**West Ryde Urban Village Development
Section 96 Application to Modify Local Development Consent No.
LDA2007/0559
Section 96 No. MOD2009/0080**

Section 96 Consent

Section 96 Consent No: MOD2009/0080

Modification of Development Consent No. LDA2007/0559 under Section 96 of the Environmental Planning and Assessment Act, 1979

DA 201^E

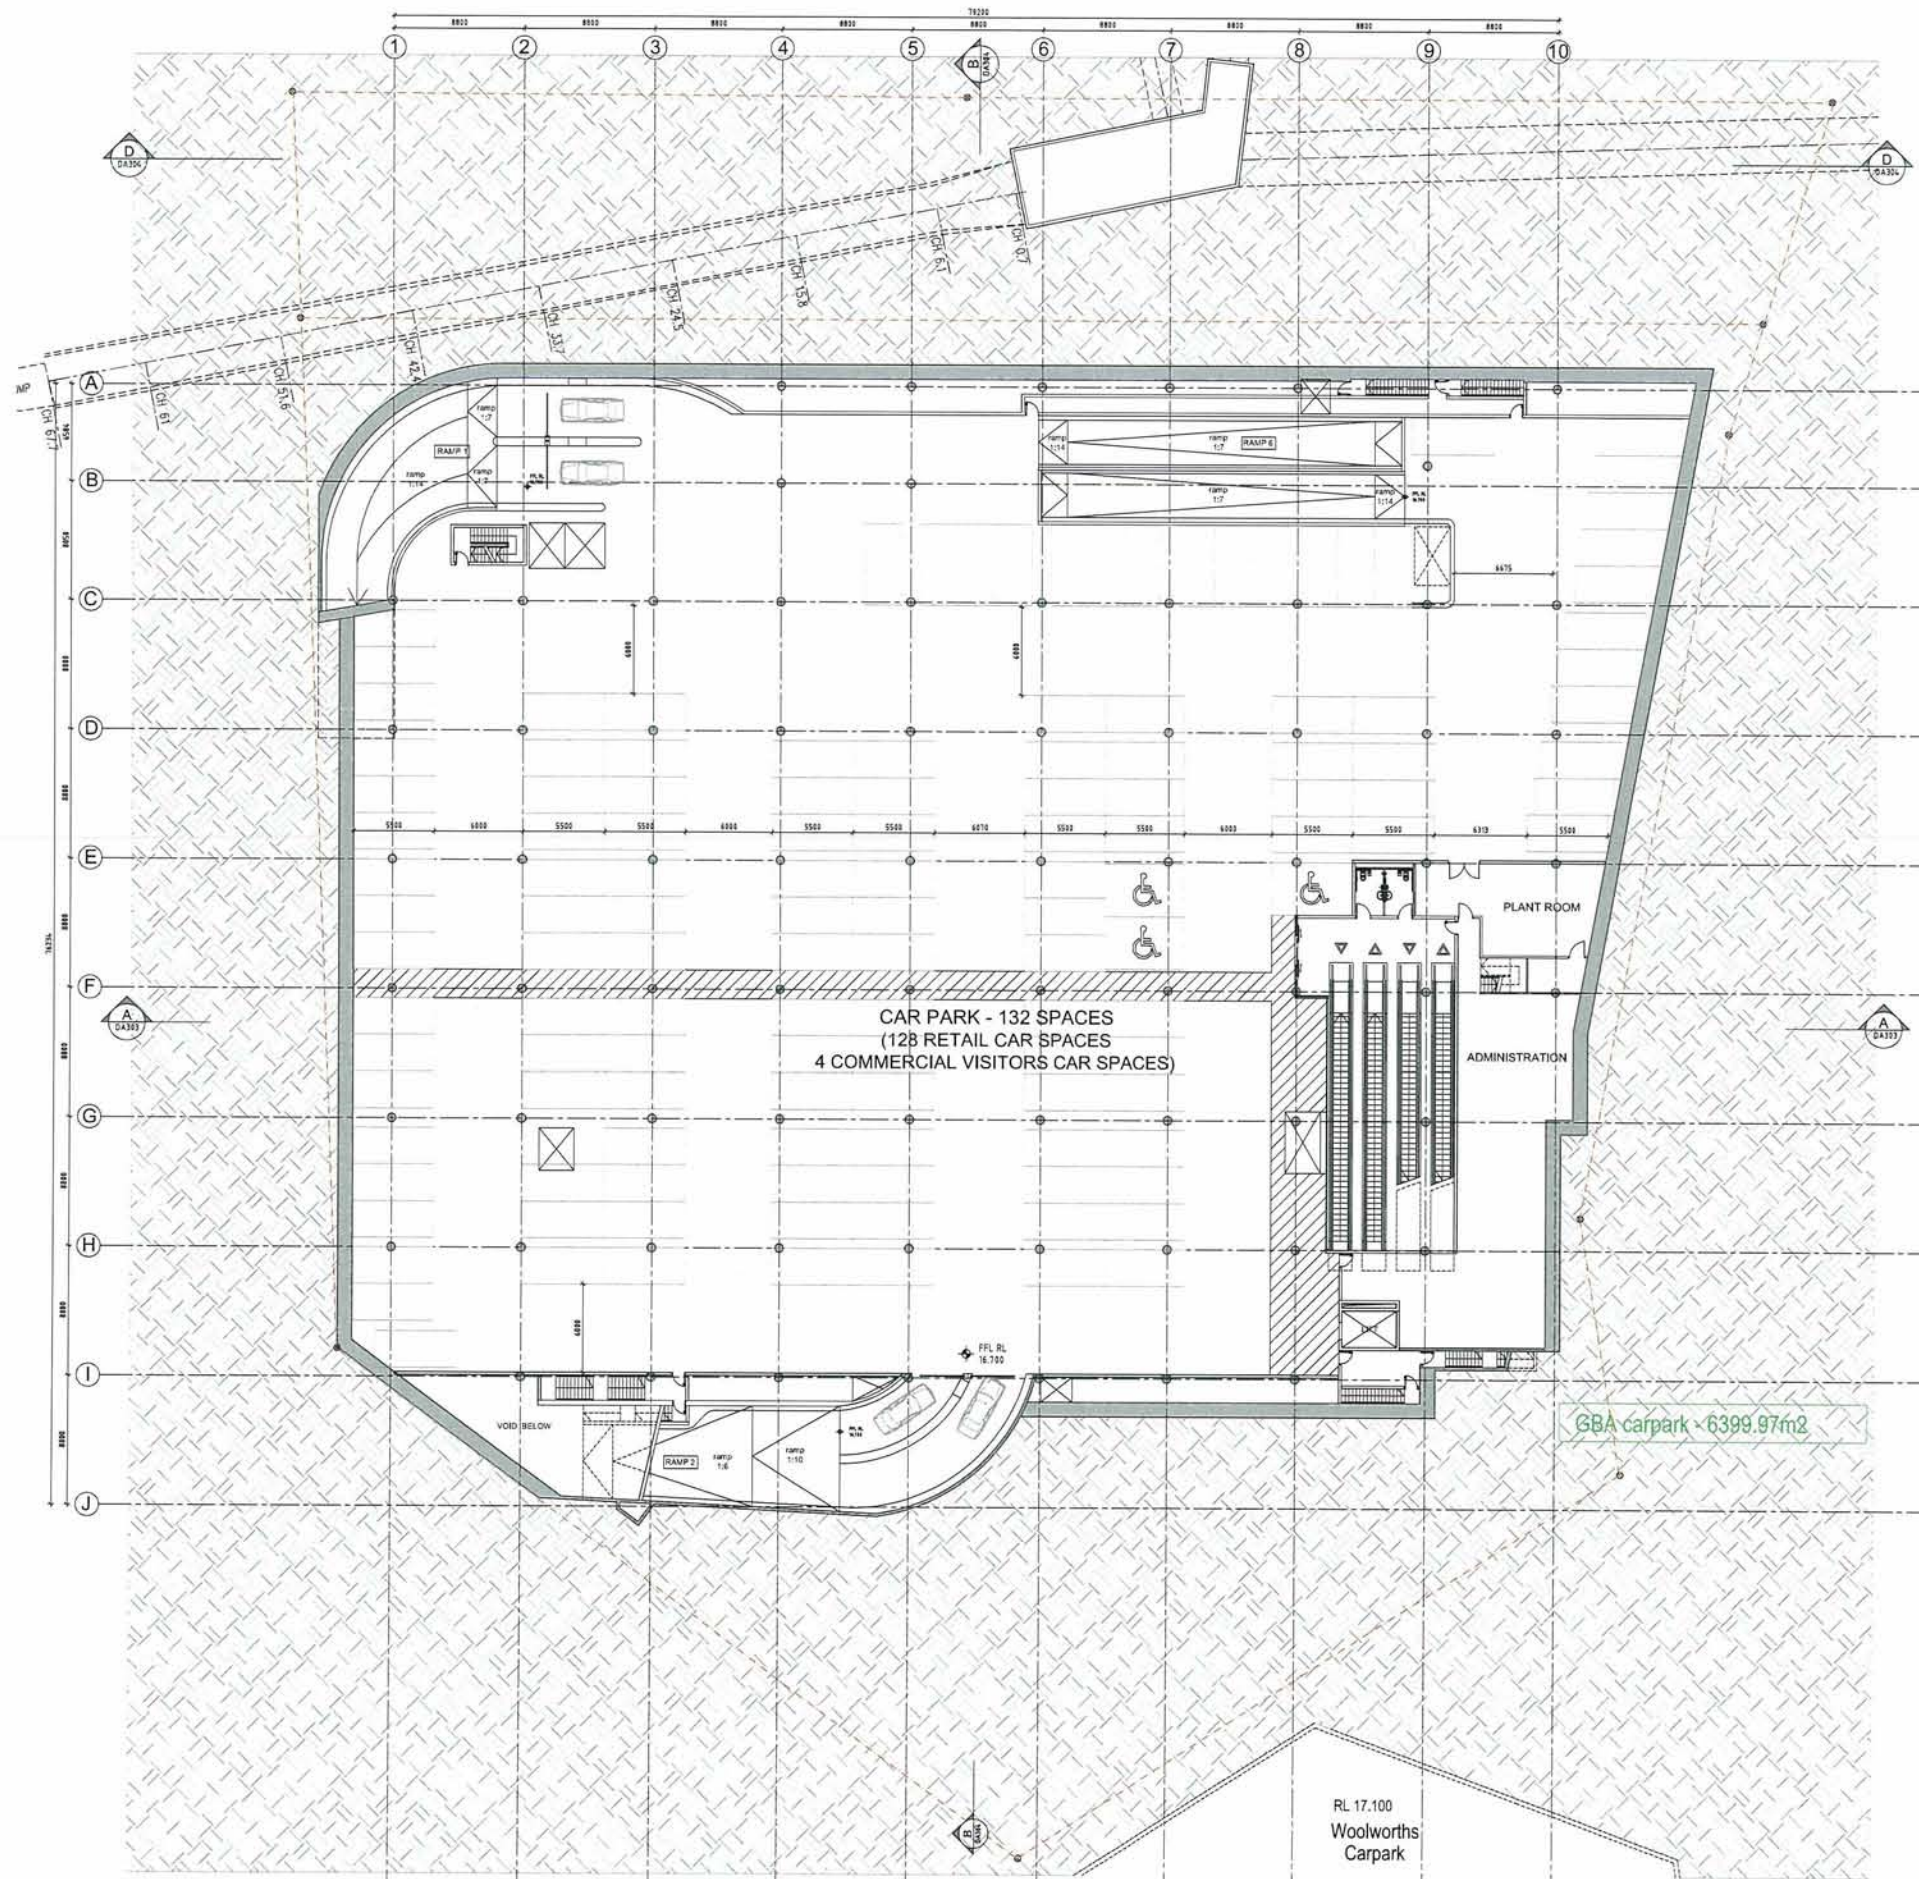
10. B-Double trucks are not permitted to access the loading dock.
11. The gates on the loading dock are to be configured to allow access to the waste storage areas shown on Plan No 210K, Ground Floor, dated March 2009.
